UNITED STATES PATENT AND TRADEMARK OFFICE

APPLICATION NO.	FILING DATE	FIRST NAMED INVENTOR	ATTORNEY DOCKET NO.	CONFIRMATION NO.
10/509,757	09/30/2004	Yuchi Terada	DK-US020721	8137
22919	7590	04/01/2008	EXAMINER	
GLOBAL IP COUNSELORS, LLP			CORRIGAN, JOSEPH JAMES	
1233 20TH STREET, NW, SUITE 700			ART UNIT	PAPER NUMBER
WASHINGTON, DC 20036-2680			3744	
MAIL DATE		DELIVERY MODE		
04/01/2008		PAPER

Office Action Summary	Application No.	Applicant(s)	
	10/509,757	TERADA, YUICHI	
	Examiner	Art Unit	
	JOSEPH CORRIGAN	3744

DETAILED ACTION

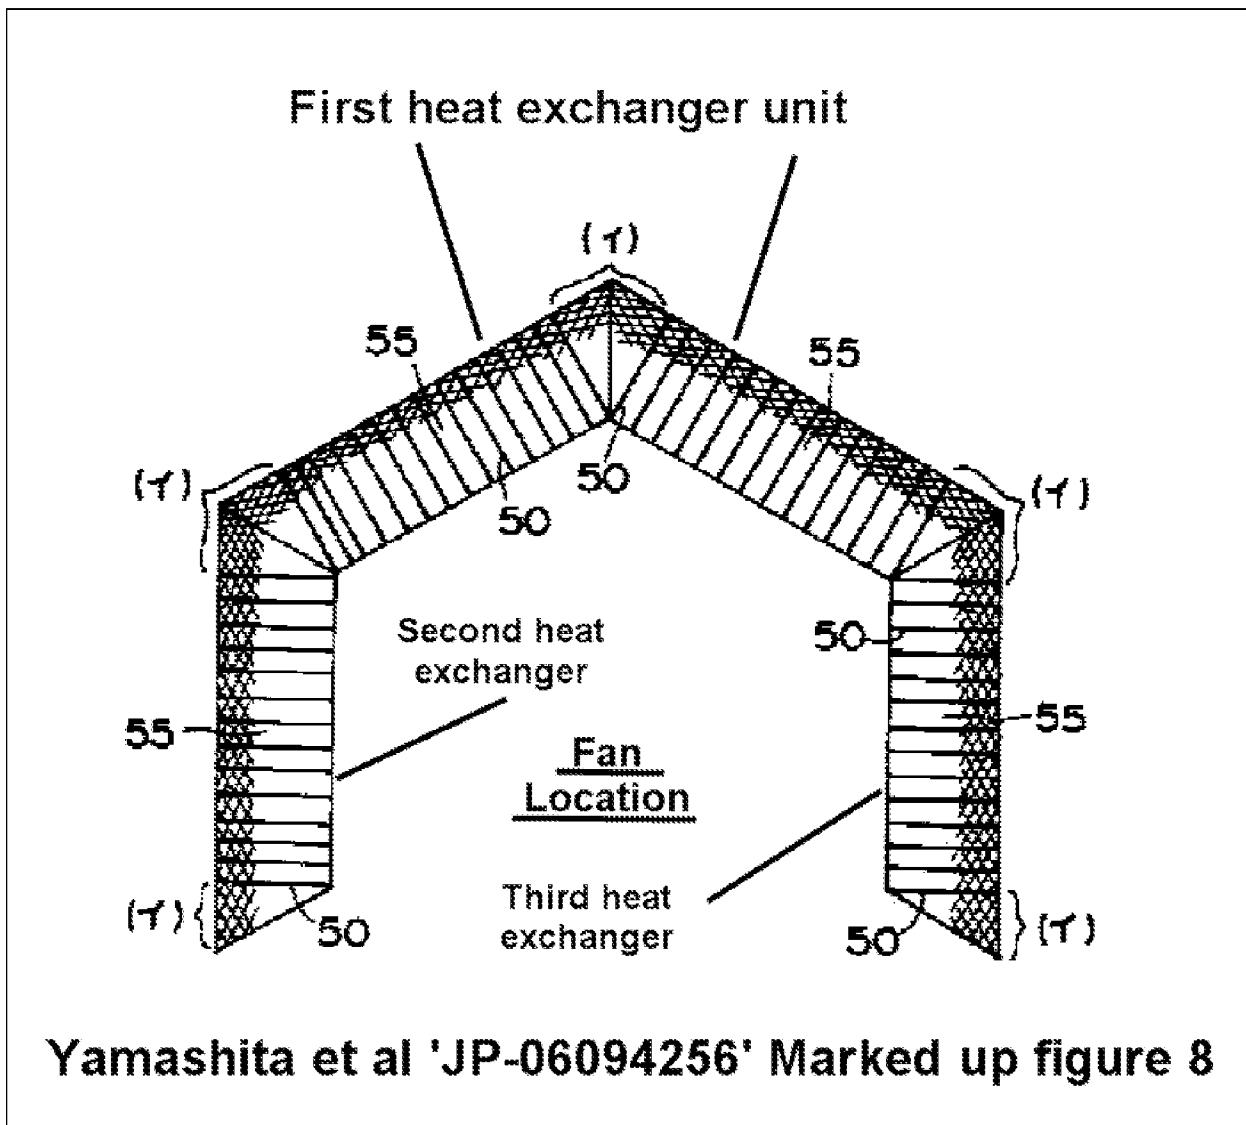
In re claim 1, Yamashita et al '256 discloses a heat exchanger (3) formed to be connected to a plurality of heat exchange units (55, figure 8), and which is disposed in an indoor unit of an air conditioner (figure 5) comprising: a first heat exchange unit having an approximate V shape in cross section (see marked up figure 8 below); second heat exchange unit (see marked up figure 8 below) that is connected at an angle with one end of the first heat exchange unit; a third heat exchange unit (see marked up figure 8 below) that is connected at an angle with another end of the first heat exchange unit; the second heat exchange unit (see marked up figure 8 below) and the third heat exchange unit (see marked up figure 8 below) have approximately the

In re claim 3, Yamashita et al '256 discloses invention above and further discloses the heat exchanger (see marked up figure 8 above) is symmetrical from front to rear (open side of heat exchanger in figure 8 is considered the back side), and the second heat exchange unit (see marked up figure 8 below) and the third heat exchange unit (see marked up figure 8 below) are symmetrical from front to rear. (see marked up figure 8 below).

Yamashita et al '256 teach a third heat exchange unit (see marked up figure 8 above) that is connected at an angle with another end of the first heat exchange unit (see marked up figure 8 above), the second heat exchange unit (see marked up figure 8 above) and the third heat exchange unit (see marked up figure 8 above) respectively extend downward from respective front and rear lower ends of the first heat exchange

unit; and the second heat exchange unit and the third heat exchange unit have approximately the same length (see marked up figure 8 above).

Yamashita et al '256 teach an inverted V-shaped heat exchanger (figure 8) made of four segments mated together (see translation, page 6 of 9, paragraph [0041], lines 4-5) wherein the first heat exchanger (see marked up figure 8) is symmetrical from front to rear, and the second heat exchange unit (see marked up figure 8) and the third heat exchange unit (see marked up figure 8) are symmetrical from front to rear surrounding fan. (See marked up figure 8 above.) (Please note that inverted V-shaped heat exchanger (taught by Yamashita) would displace inverted V-shaped heat exchanger shown in Asami et al '326, figure 4, surrounding fan).

Sato JP-2001/141256A Marked up figure 5B

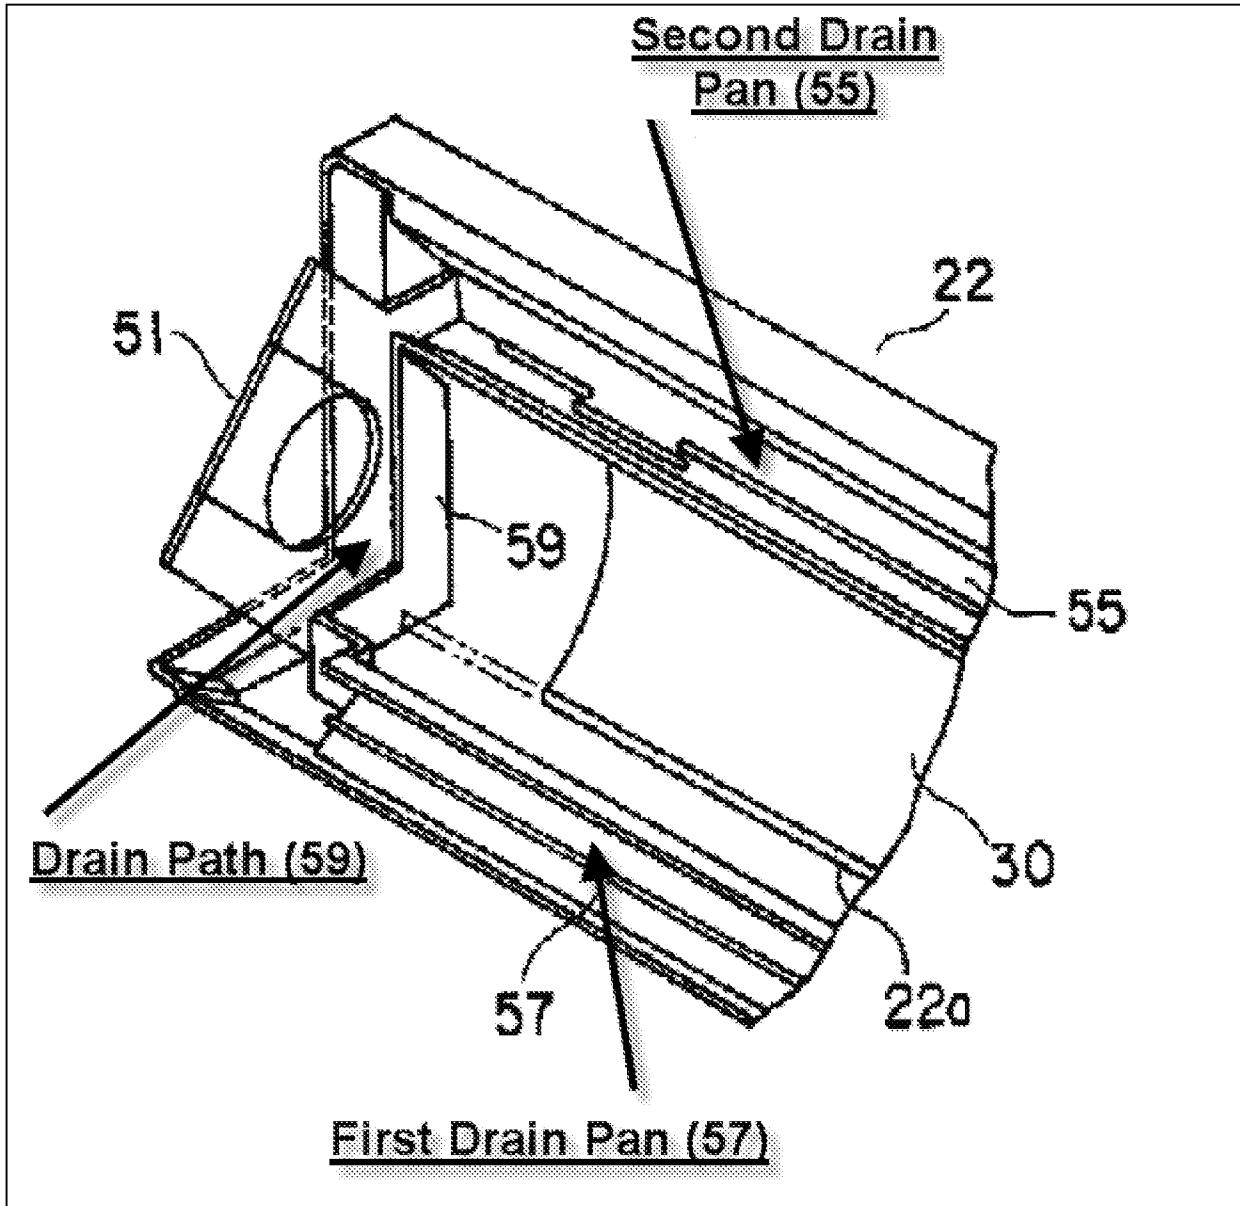
Sato et al '256 discloses a first drain pan (57, marked up figure 5B above) that is disposed below the lower front end of the heat exchanger (Yamashita); a second drain

pan (55, marked up figure 5B above) that is disposed below the lower rear end of the heat exchanger (56, marked up figure 5 B above); a drain path (59, marked up figure 5B above) through which drain water discharged from the first drain pan (57) and the second drain pan (55) passes.
